RE: **2-ZN-2024**

Artessa

Planning & Development Services has completed review of the above referenced development application. The following comments represent issues or deficiencies identified by the review team and are intended to provide you with guidance for compliance with city codes, policies, and guidelines.

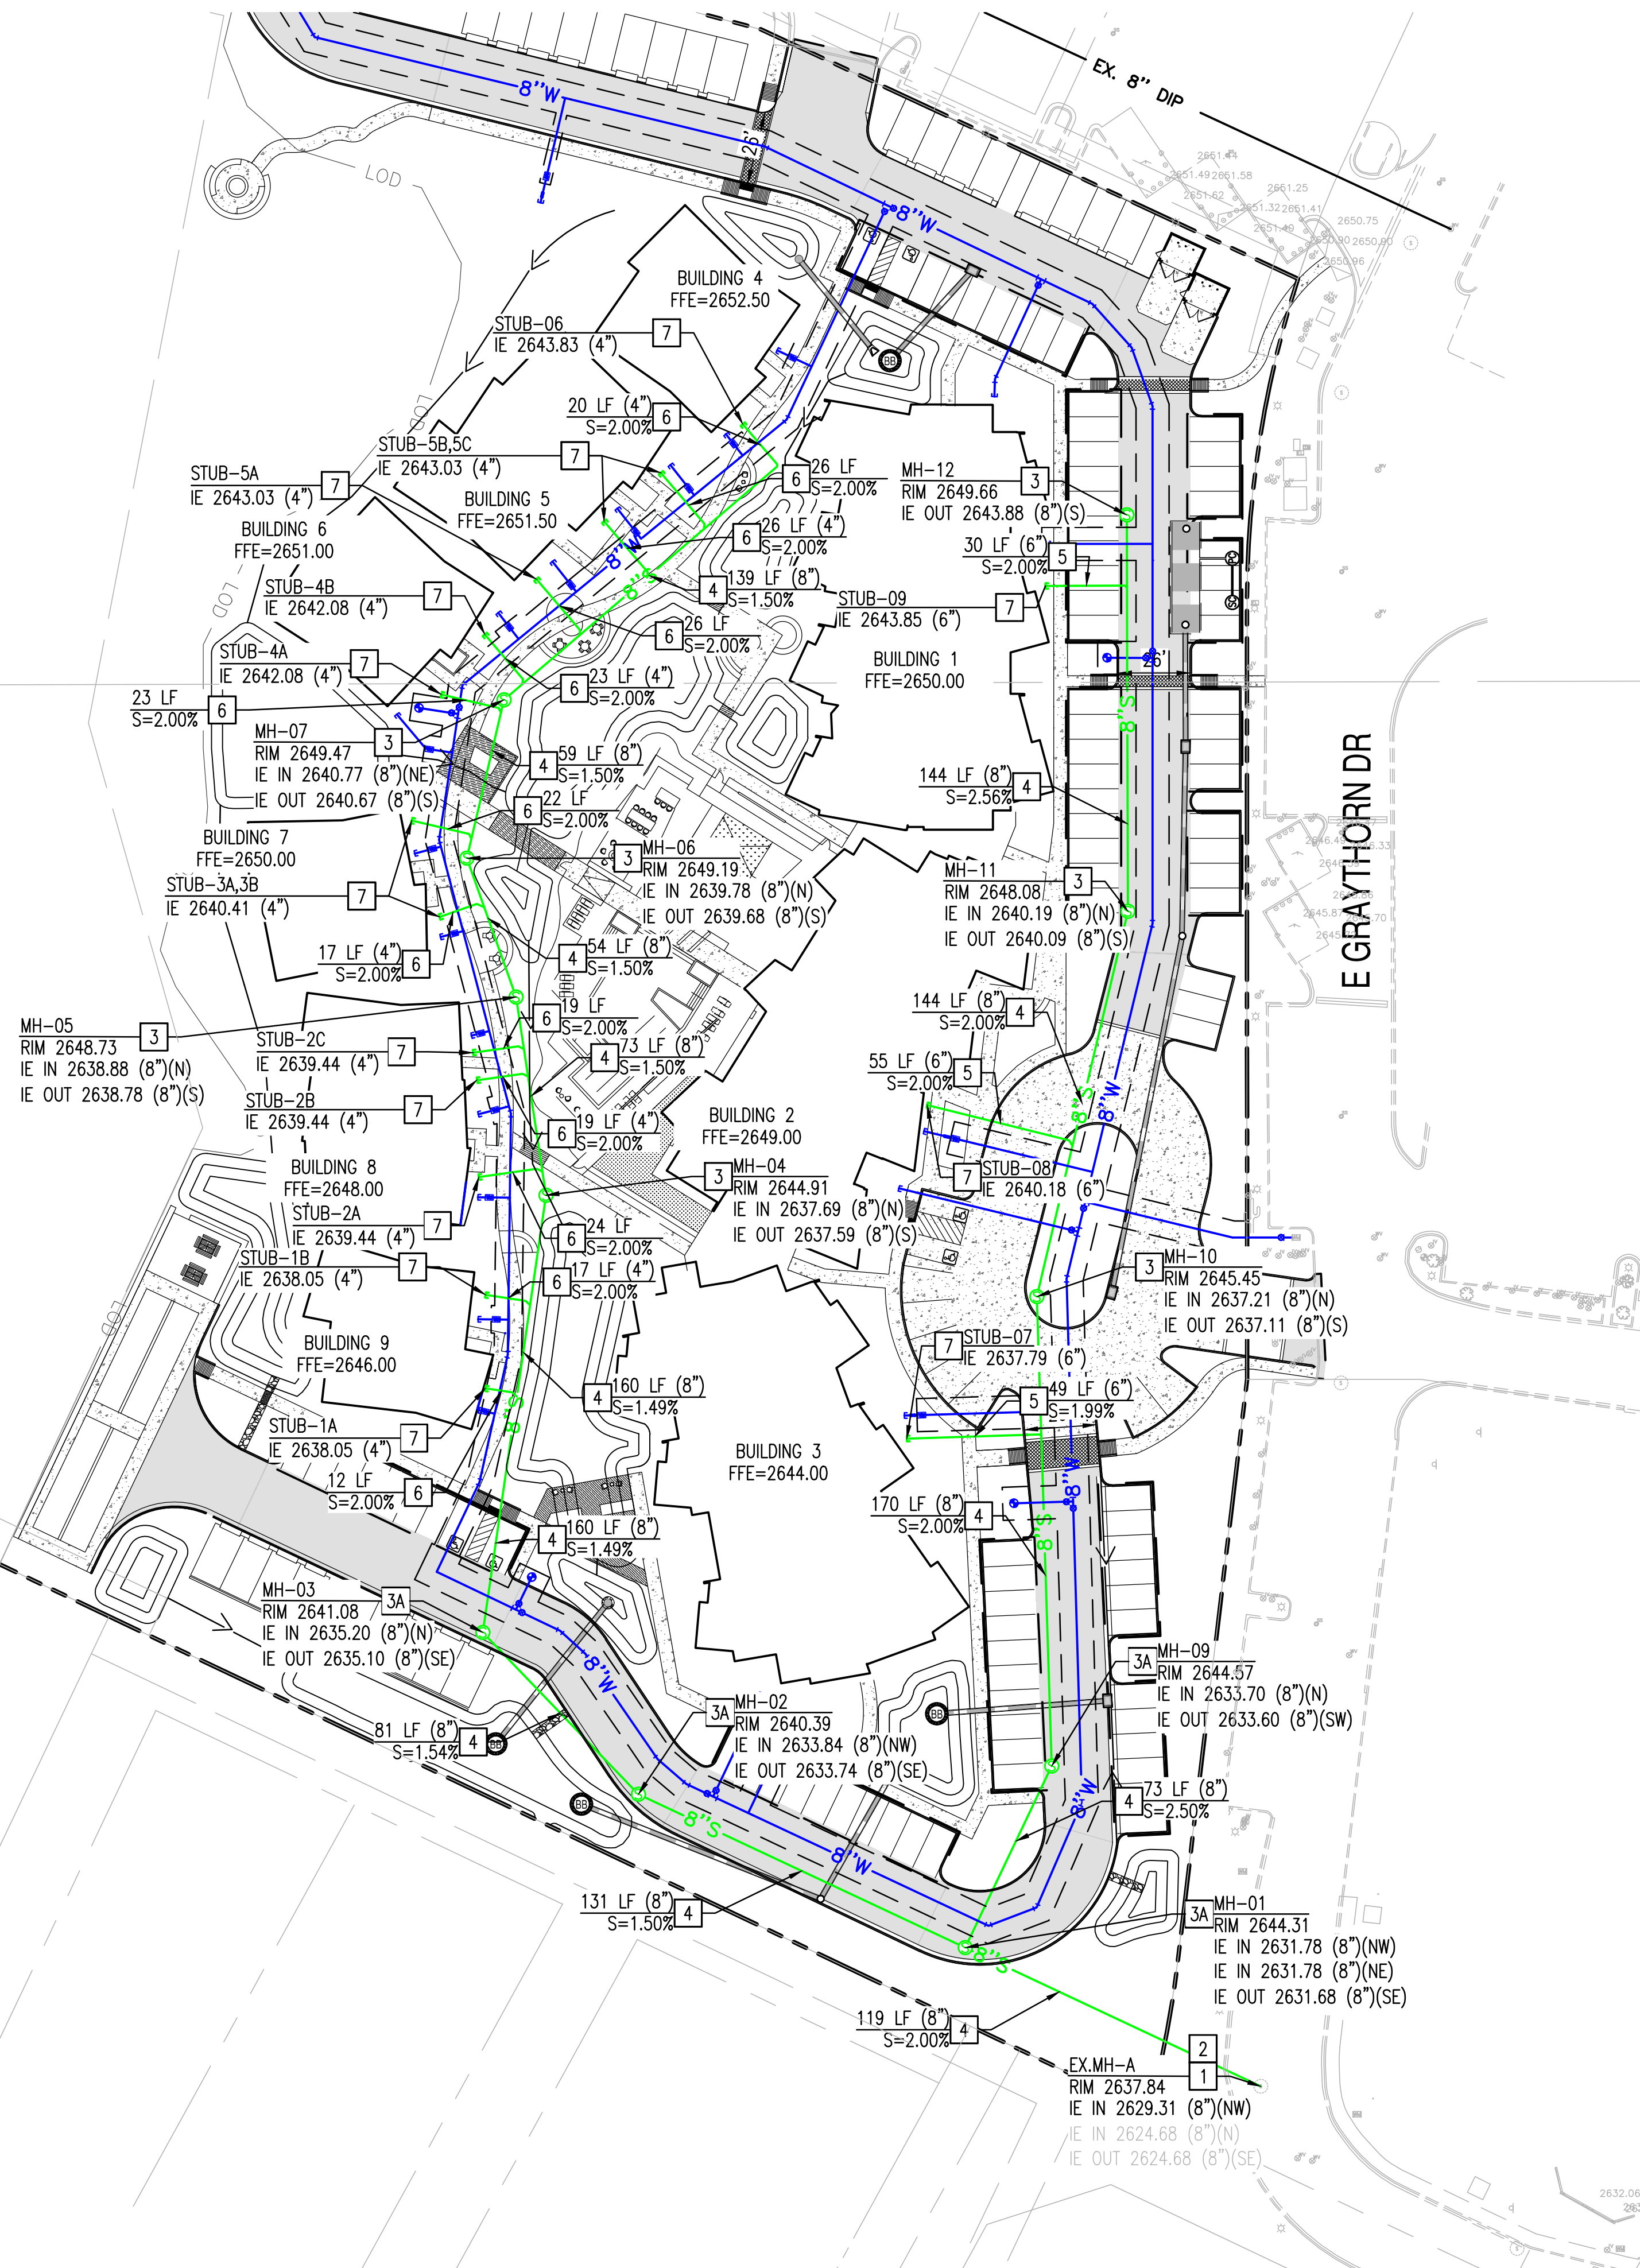
Specify Private Sewer

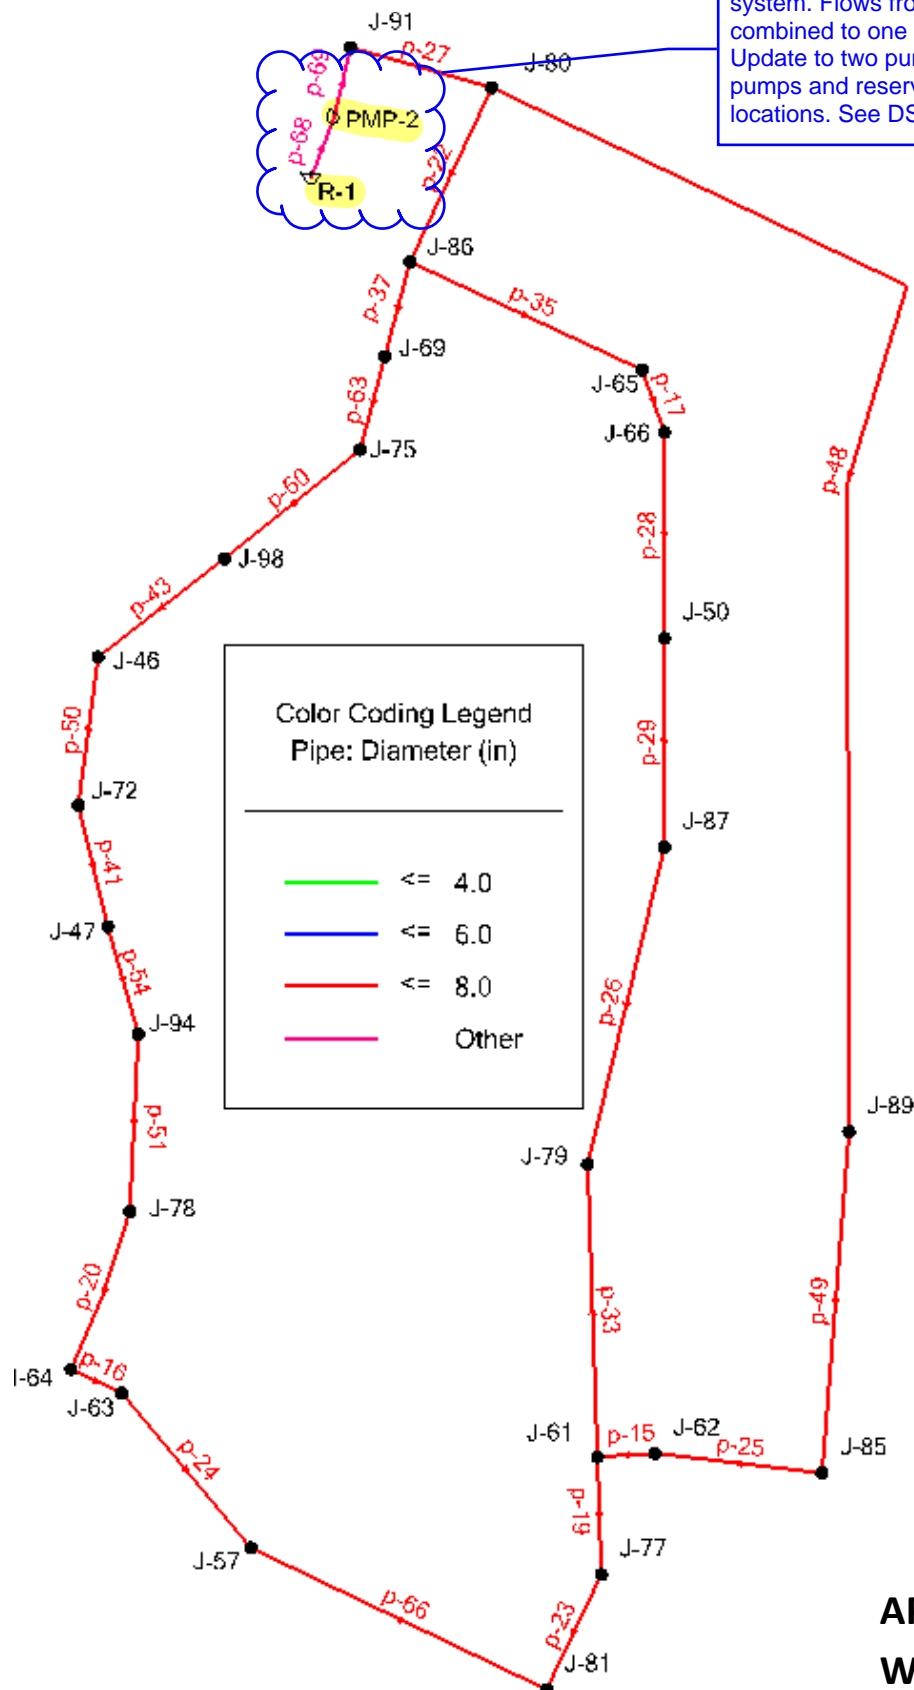
Based on Fire Hydrant flow test, this is a two pump system. Flows from two fire hydrants cannot be combined to one hydrant in hydraulic modeling. Update to two pump modeling system and relocate pumps and reservoirs based on their actual locations. See DSPM Section 6-1.202.

Network diagram does not match with Water Plan Sheet C4.11. Update network diagram per DSPM Section 6-1.202.
